**Decision Document  
GAMBELL FORMERLY USED DEFENSE SITE  
F10AK0696  
St. Lawrence Island, Alaska**

**June 2005**

## **Proposed Plan for Remedial Action, Gambell FUDS, St. Lawrence Island, Alaska July 2004**

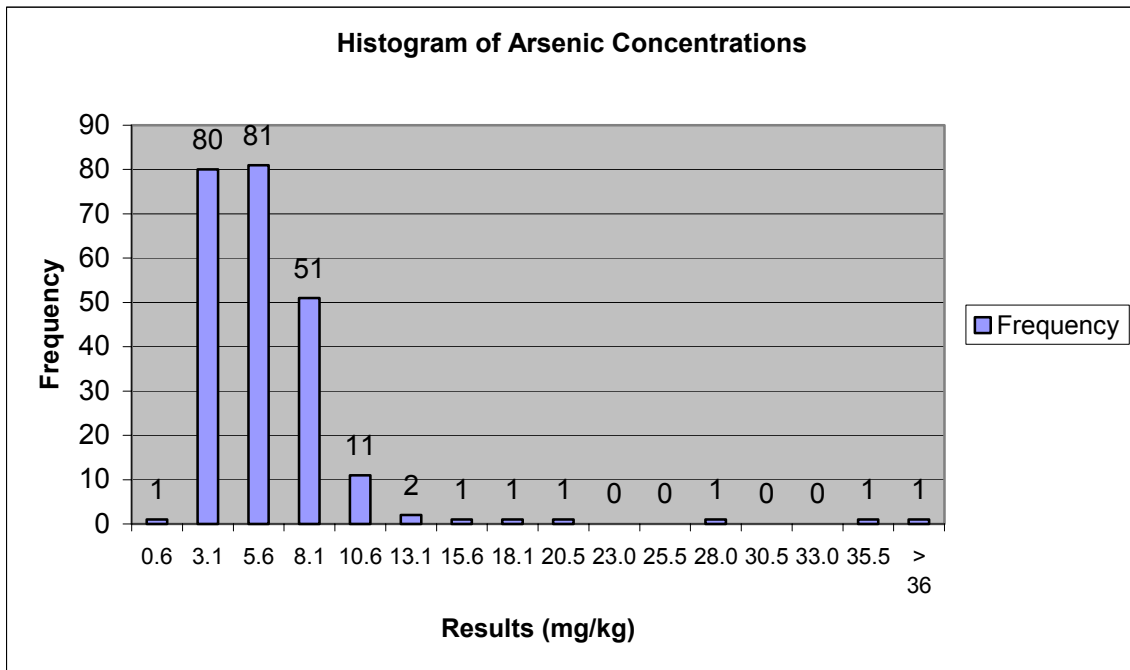
Throughout the document, arsenic levels are considered “attributable to background” and not of military source. In some cases, arsenic levels are averaged and no further action is justified based on an average concentration. This is inappropriate and unjustified. True background levels are not provided. Often arsenic levels exceed ADEC cleanup standards. These sites should be remediated so that arsenic levels are below ADEC cleanup standards.

It is appropriate to use average concentrations of arsenic on a site-specific basis. The U.S. Environmental Protection Agency (US EPA) recommends calculating a reasonable maximum exposure (RME) for residential scenarios. Thus, the RME for chronic exposure on a site-specific basis is estimated using an average concentration of a chemical of concern. Average concentrations are typically derived by statistical methods by calculating the 95% Upper Confidence Level on the arithmetic mean of a dataset. U.S. EPA’s Soil Screening Guidance Fact Sheet (July 1996) states that “For data sets of lesser quality, the 95% upper confidence level on the arithmetic mean of contaminant soil concentrations can be compared directly to the SSLs [soil screening levels]. The TBD [Soil Screening Guidance: Technical Background Document (U.S. EPA 1996)] discusses strengths and weaknesses of different calculations of the mean and when they are appropriate for making screening decisions.”

A statistical evaluation of the entire dataset (232 data points) of arsenic concentrations (excluding all non-detects) in Gambell demonstrates that 96.6% of the data falls below 10.6 ppm and 97.4% of the data fall below 13.1 ppm. This dataset includes locations which have been subsequently removed during remedial actions at the site (e.g., the sample result of 38 ppm at Site 4B from 1994), or are planned for removal (e.g., confirmation sampling results from Site 7 in 2003 of 27.9 and 34.9 ppm). A histogram of the data distribution is shown below, with the number of samples in each evenly spaced “bin” (i.e., an equally spaced interval) shown. The average arsenic concentration is 5.0 mg/kg, with a standard deviation of 4.2, and a 95% upper confidence level of 6.2 mg/kg (Chebyshev, non-parametric method).
